I object to the WestConnex M4-M5 Link proposals as contained in the EIS application # SSI 7485, for the reasons set out below.

Application Number: SSI 7485

Application Name: WestConnex M4-M5 Link

Figure 6-4 Project footprint - Map 2

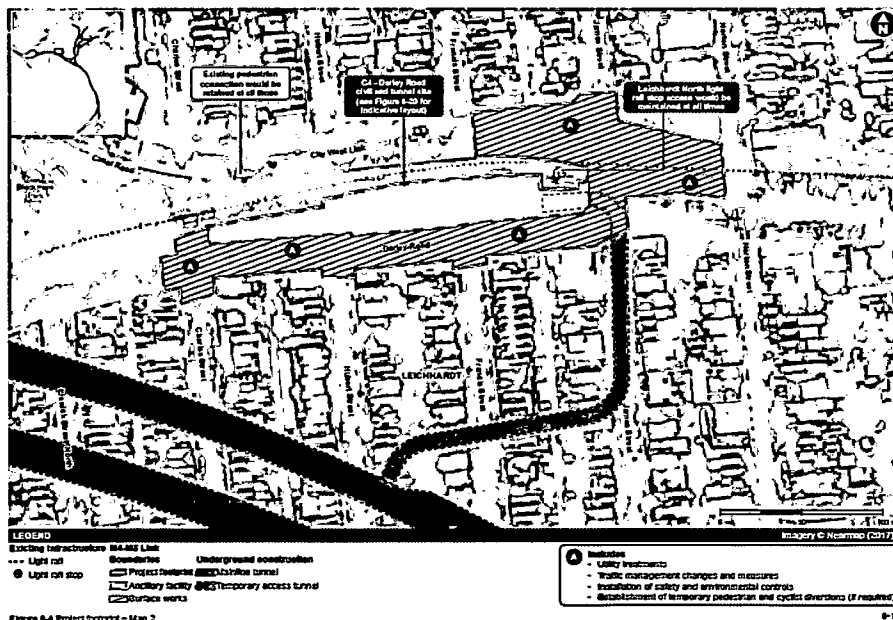
2. I object to the EIS because it does not guarantee that the existing access to the Leichhardt North light rail stop would be maintained at all times. Fig 6-4 indicates that only the eastern access will be maintained. This greatly disadvantages the elderly and disabled who have to walk up a steep hill to the eastern access. If the proponent cannot guarantee access to the Leichhardt North light rail stop from the existing entry points or from points that are accessible to all then the Darley Road, Leichhardt construction site should be abandoned. The proponent should be directed to find a site where its operations will not impact on users of the Light Rail.

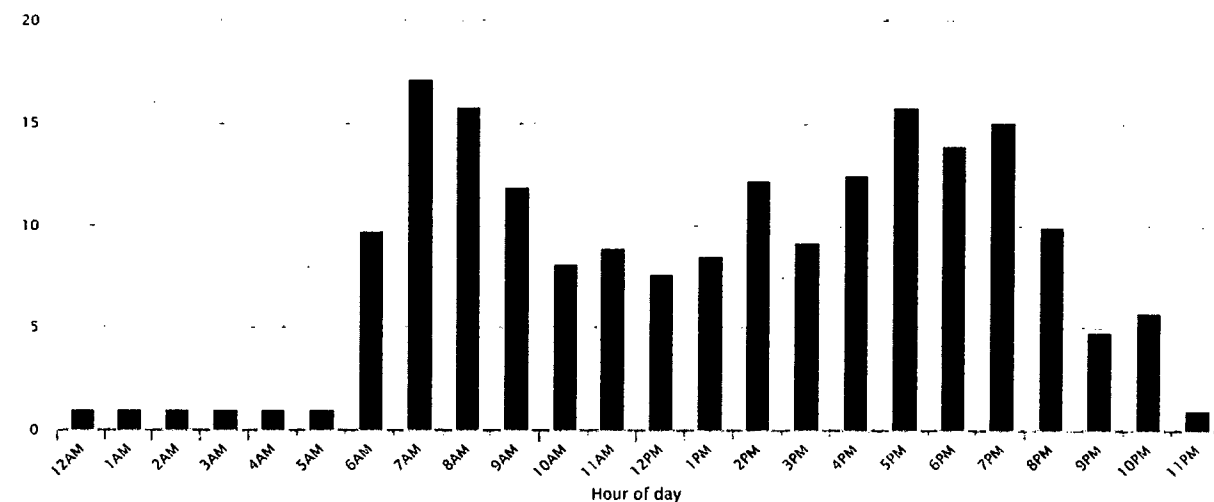
- I object to the EIS because the proponent has failed to take account of the cumulative impact of its proposed Darley Road, Leichhardt civil and tunnel site operations and the aircraft noise which the residents near the site already endure.

The attached extract from Webtrak shows that Darley Road, Leichhardt and adjacent streets are directly under the flight path. Airservices Australia reports that in April to June 2017 the number of average daily noise events over 70 dBA. In Leichhardt this is an average of 16-17 per hour over the peak morning period and 16 per hour in the early evening peak period.

Figure 6-4 Project footprints - Map 2

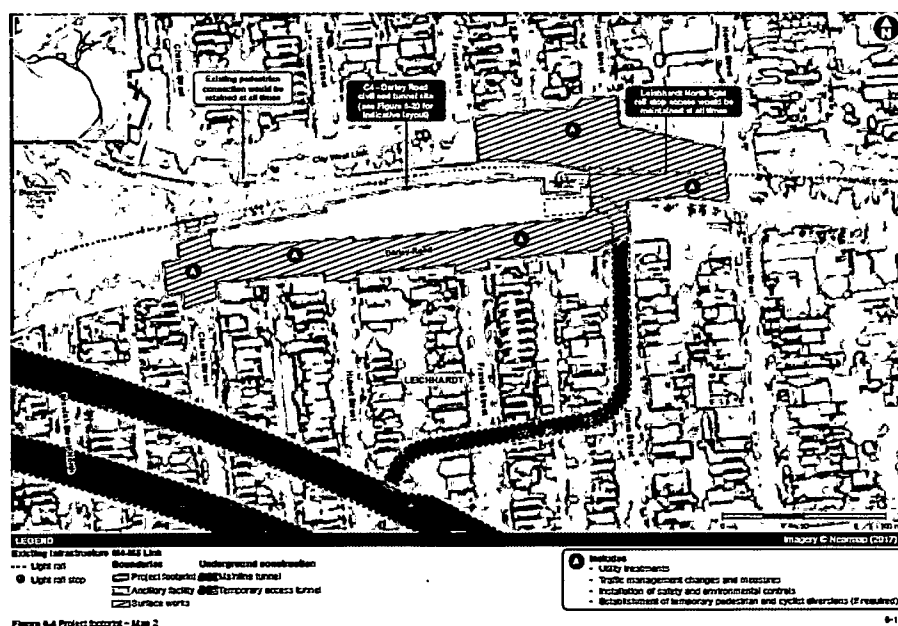
2. I object to the EIS because it does not guarantee that the existing access to the Leichhardt North light rail stop would be maintained at all times. Fig 6-4 indicates that only the eastern access will be maintained. This greatly disadvantages the elderly and disabled who have to walk up a steep hill to the eastern access. If the proponent cannot guarantee access to the Leichhardt North light rail stop from the existing entry points or from points that are accessible to all then the Darley Road, Leichhardt construction site should be abandoned. The proponent should be directed to find a site where its operations will not impact on users of the Light Rail.

The EIS states in 6.5.8 Darley Road civil and tunnel site (C4) that:

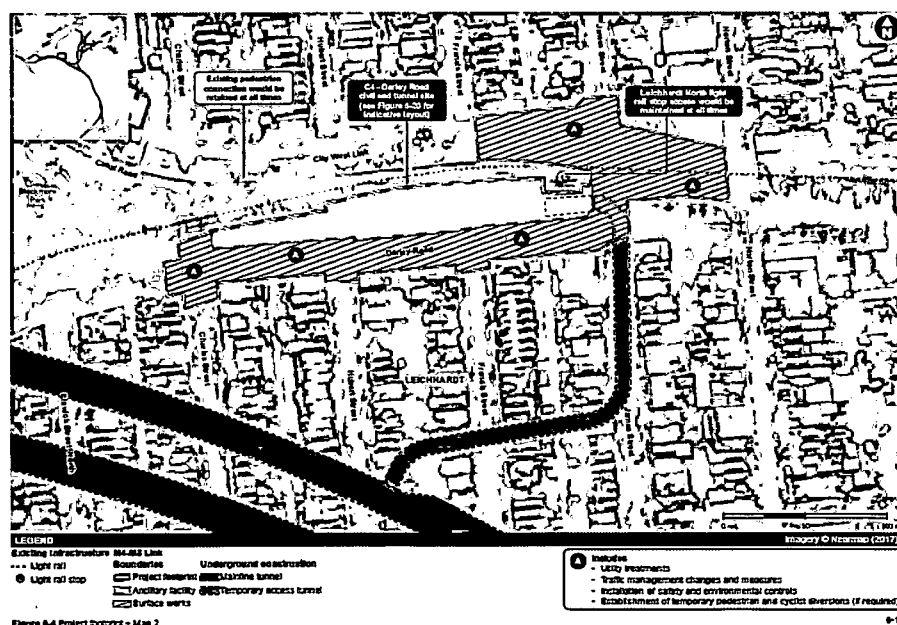
- I object to the EIS because it fails to describe the temporary changes to Darley Road, Leichhardt to enable access to and from the ancillary facility that would likely be required in relation to the Darley Rd site and instead allows for the final plan to be decided by the contractor.

It is not clear how continued access, pedestrian and cyclist movement will be preserved and I am concerned that the impacts have not been correctly identified and assessed by the proponent.

Figure 6-4 Project footprint - Map 3

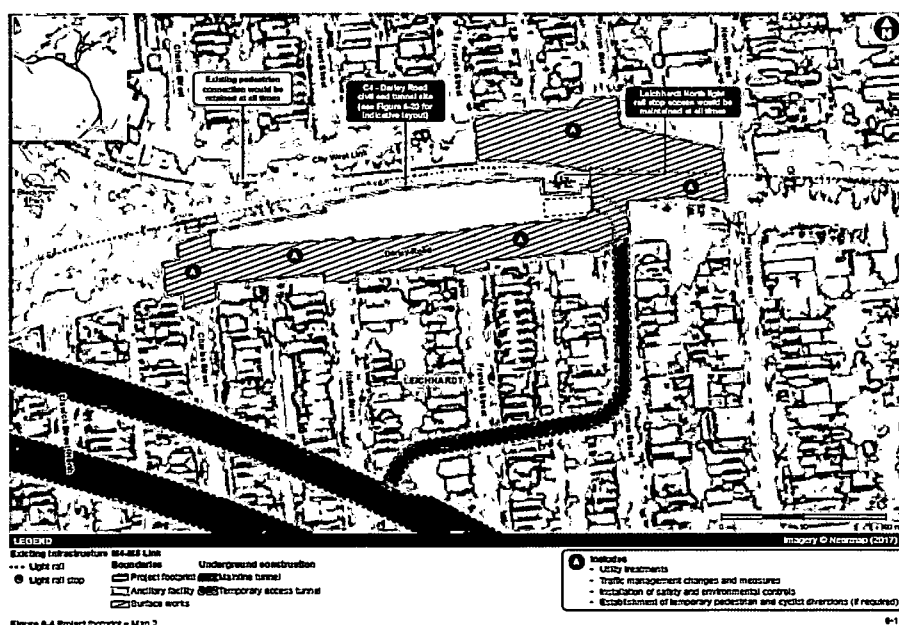
- I object to the EIS because it does not guarantee that the existing access to the Leichhardt North light rail stop would be maintained at all times. Fig 6-4 indicates that only the eastern access will be maintained. This greatly disadvantages the elderly and disabled who have to walk up a steep hill to the eastern access. If the proponent cannot guarantee access to the Leichhardt North light rail stop from the existing entry points or from points that are accessible to all then the Darley Road, Leichhardt construction site should be abandoned. The proponent should be directed to find a site where its operations will not impact on users of the Light Rail.

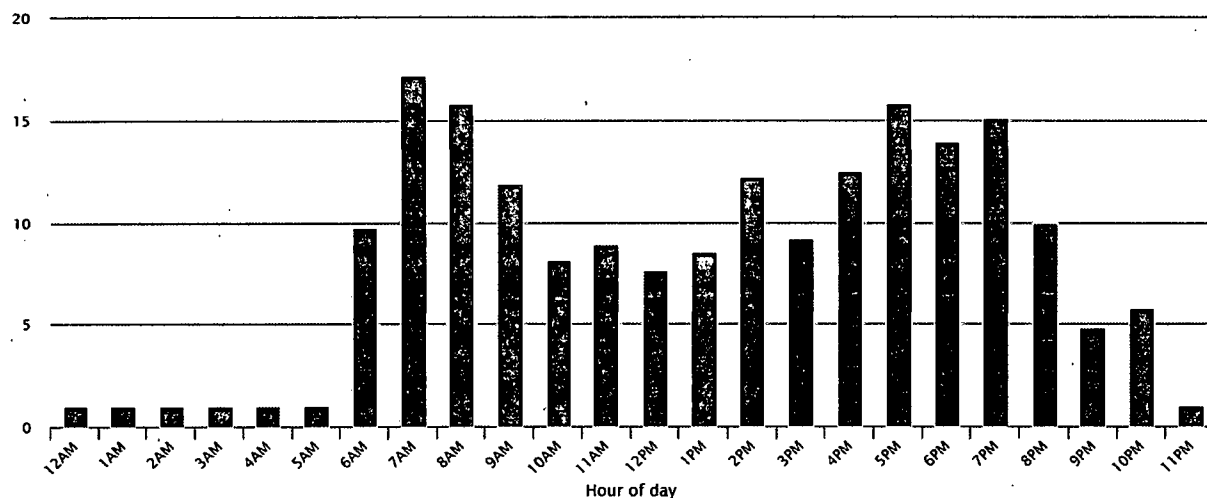
- I object to the EIS because the proponent has failed to take account of the cumulative impact of its proposed Darley Road, Leichhardt civil and tunnel site operations and the aircraft noise which the residents near the site already endure.

The attached extract from Webtrak shows that Darley Road, Leichhardt and adjacent streets are directly under the flight path.

Airservices Australia reports that in April to June 2017 the number of average daily noise events over 70 dBA. In Leichhardt this is an average of 16- 17 per hour over the peak morning period and 16 per hour in the early evening peak period.

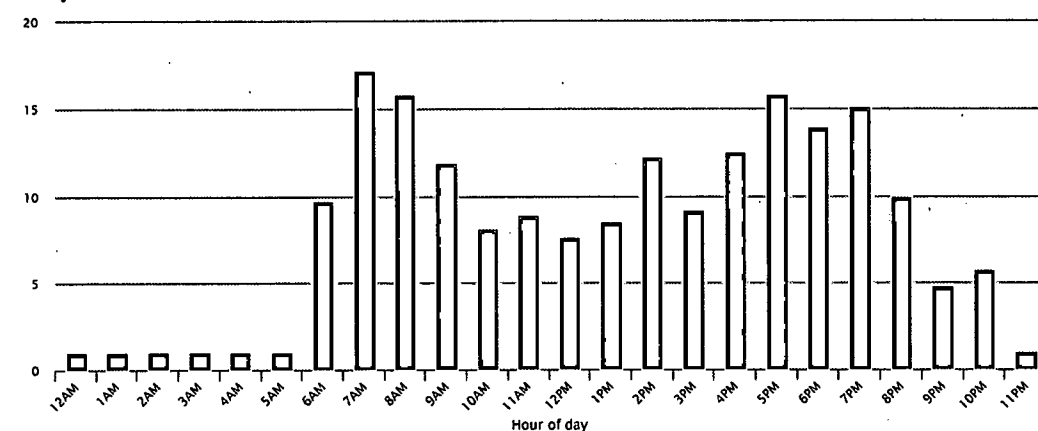
- I object to the EIS because the proponent has failed to take account of the cumulative impact of its proposed Darley Road, Leichhardt civil and tunnel site operations and the aircraft noise which the residents near the site already endure.

The attached extract from Webtrak shows that Darley Road, Leichhardt and adjacent streets are directly under the flight path.

Figure 6-4 Project footprint - Map 2

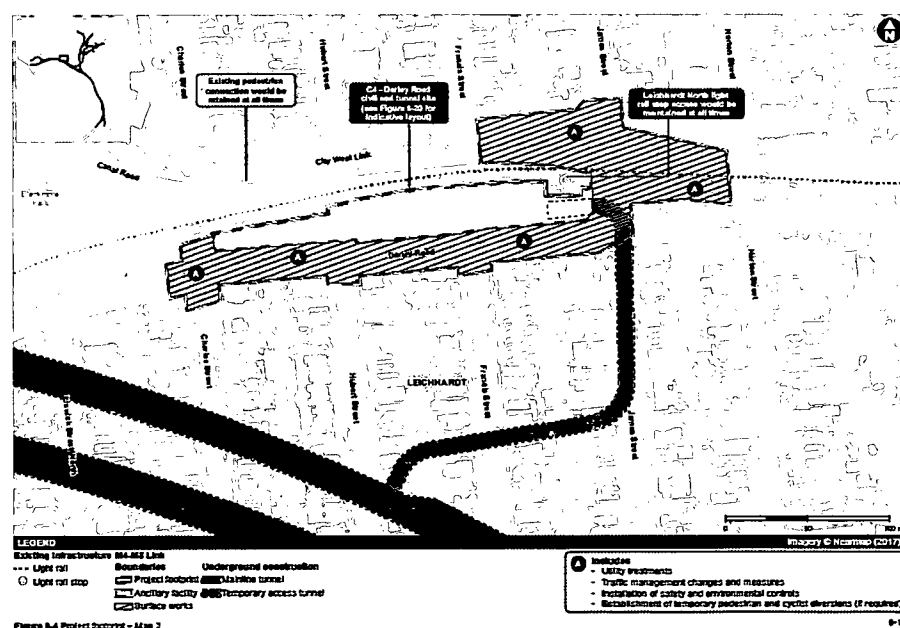
2. I object to the EIS because it does not guarantee that the existing access to the Leichhardt North light rail stop would be maintained at all times. Fig 6-4 indicates that only the eastern access will be maintained. This greatly disadvantages the elderly and disabled who have to walk up a steep hill to the eastern access. If the proponent cannot guarantee access to the Leichhardt North light rail stop from the existing entry points or from points that are accessible to all then the Darley Road, Leichhardt construction site should be abandoned. The proponent should be directed to find a site where its operations will not impact on users of the Light Rail.
